From: gms@midplains.coop
To: [Ohori, David, EMNRD](#)
Cc: [Jeronimo Weber](#)
Subject: [EXT] Palm Park exploration application
Date: Friday, November 1, 2019 8:35:52 AM
Attachments: [detail map 1 10 31 19.pdf](#)
[detail map 2 10 31 19.pdf](#)
[detail map 3 10 31 19.pdf](#)

I have reviewed the application for the Palm Park minimal impact exploration permit and need some additional information in order to continue processing the application:

PALM PARK CLAIM GROUP
Drill Hole and Access Road Display
Dona Ana County, New Mexico

(505) 476-3402 FAX
david.ohori@state.nm.us

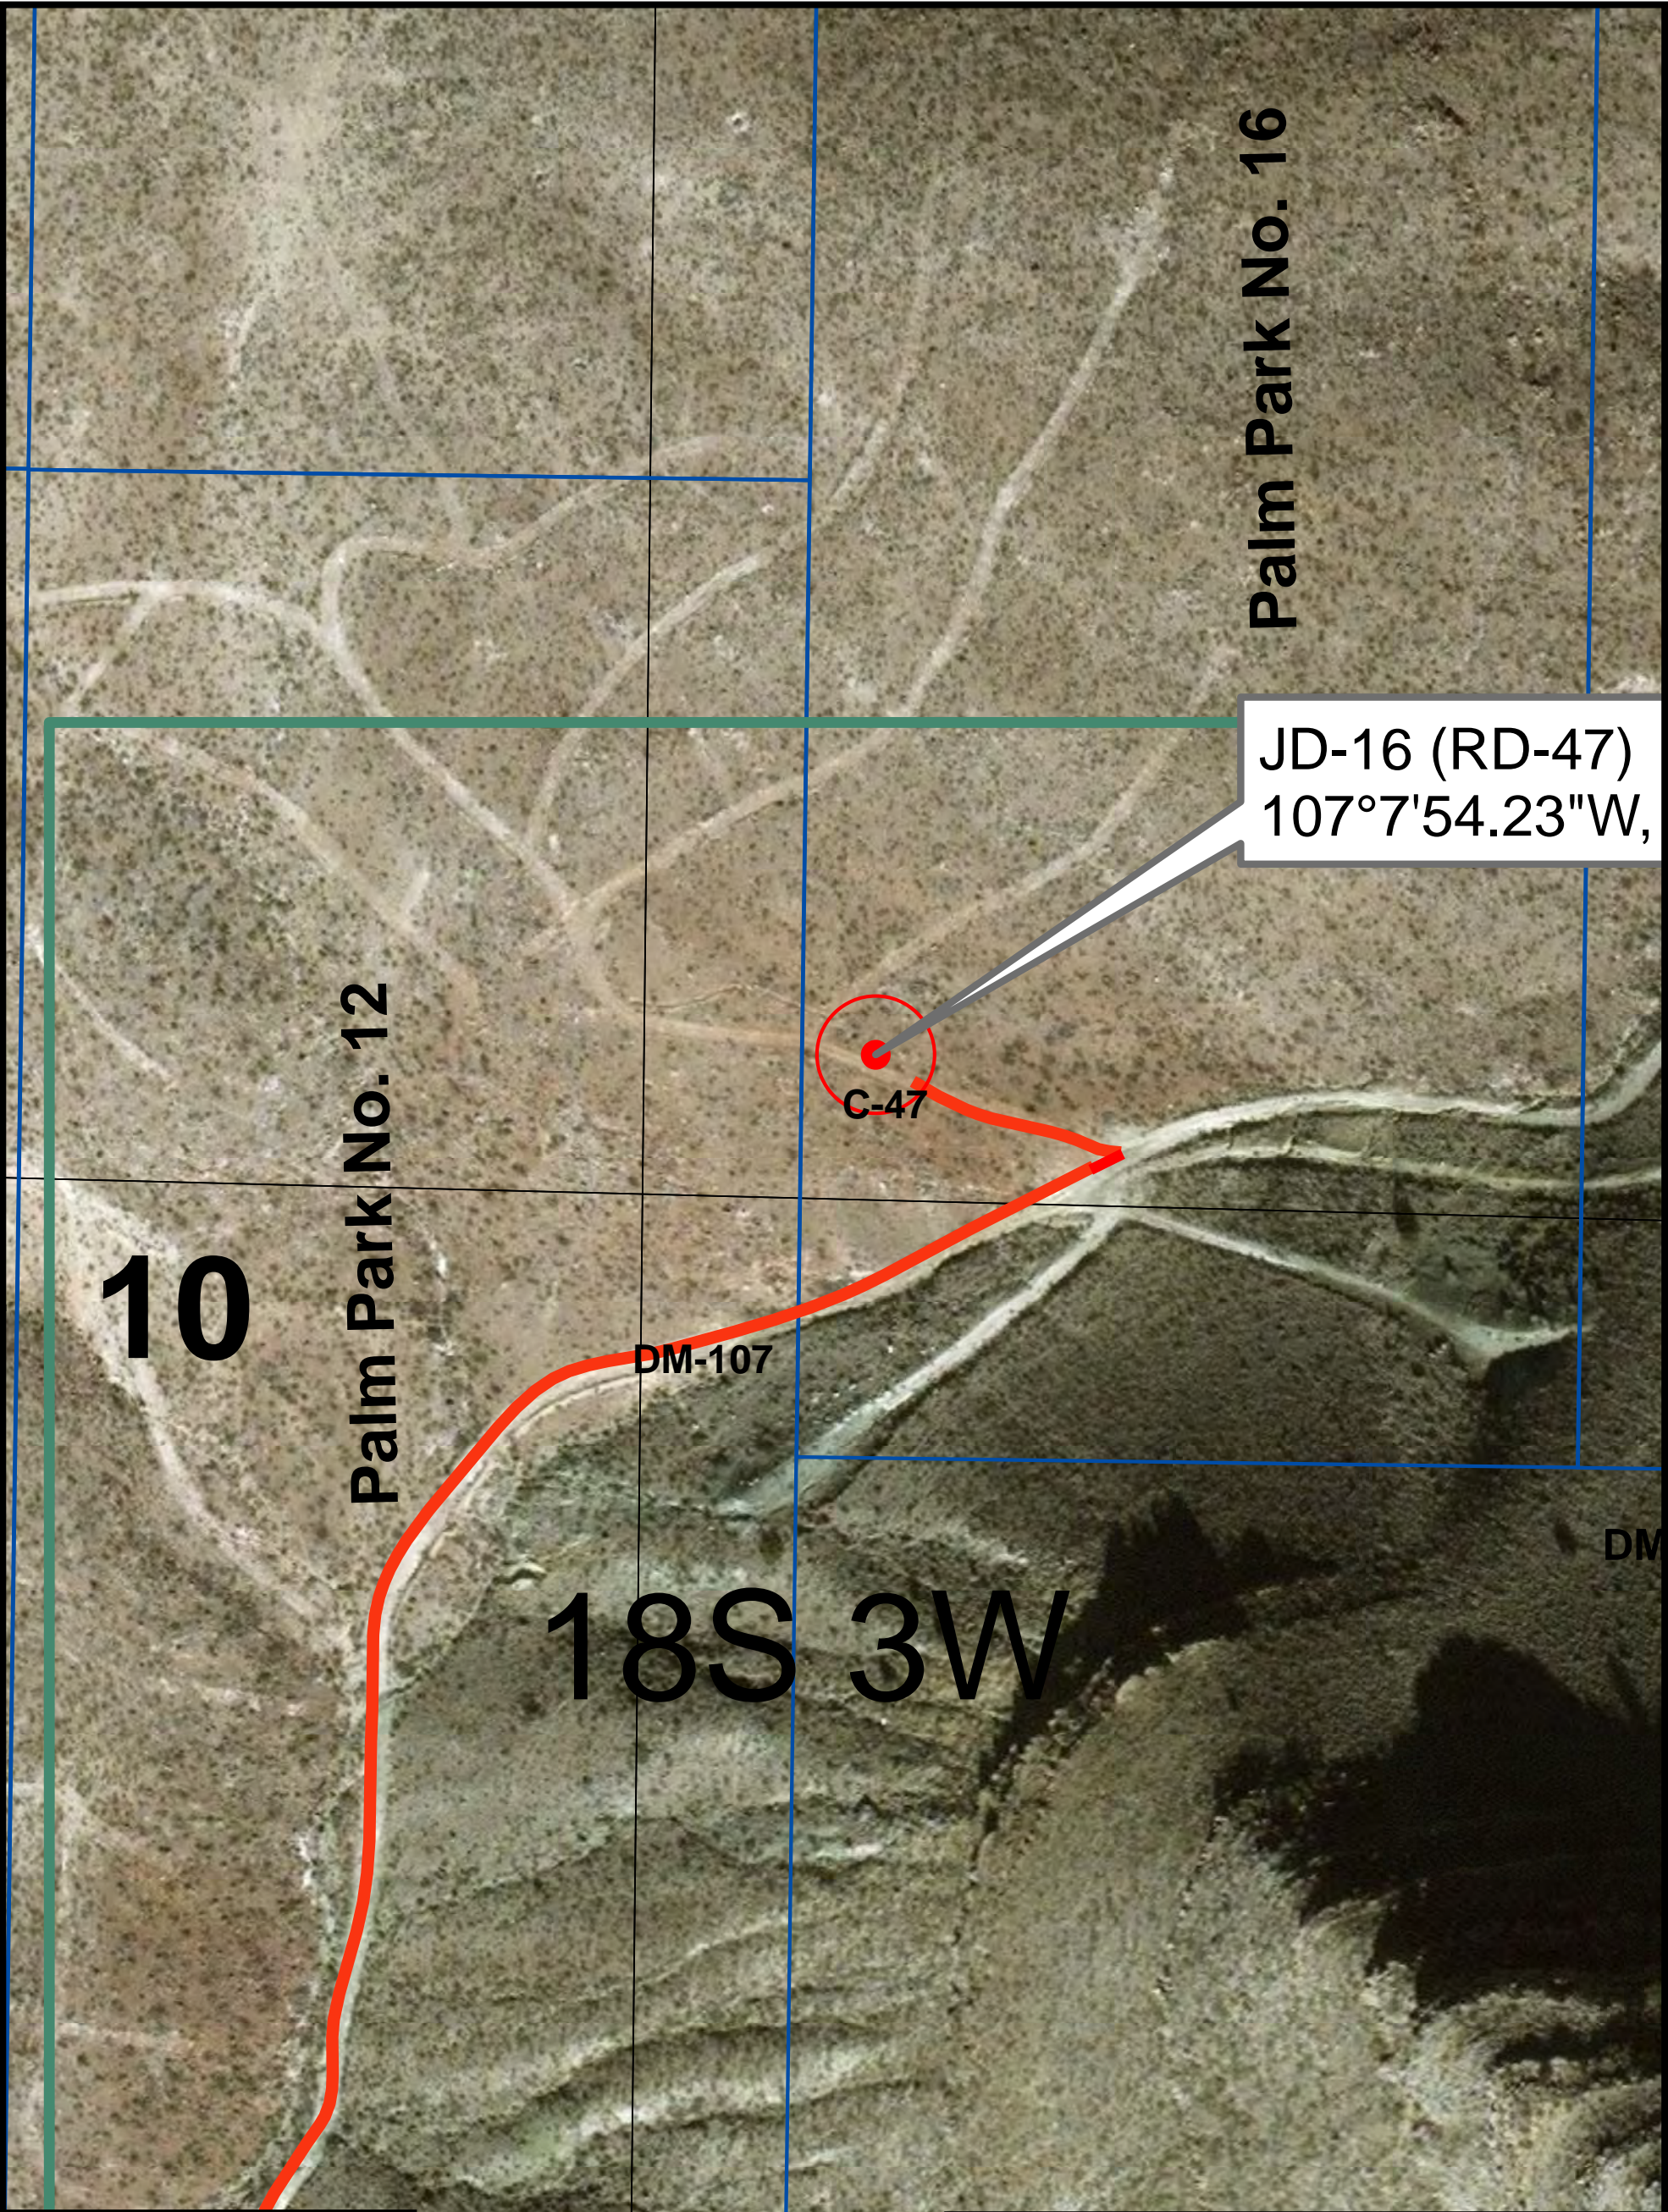
7. Page 13, Section F. Roads and Overland Travel, indicates that there will be 500 feet of overland travel routes, 12 feet wide causing approximately 0.14 acres of disturbance. The proposed overland travel routes are difficult to identify and see clearly on the large scale maps provided in the application. Please provide additional smaller scale maps that clearly show the proposed overland travel routes.

Please review the three attached maps which show the existing roads and bore hole locations. All bore hole locations, except for JD-3, are less than 50' from an existing access road. JD-3 is approximately 80' from an existing road but is less than 50' from JD-4. The 30'x50' drill pads will allow the drilling rig to enter directly from existing access roads onto the drill pads.
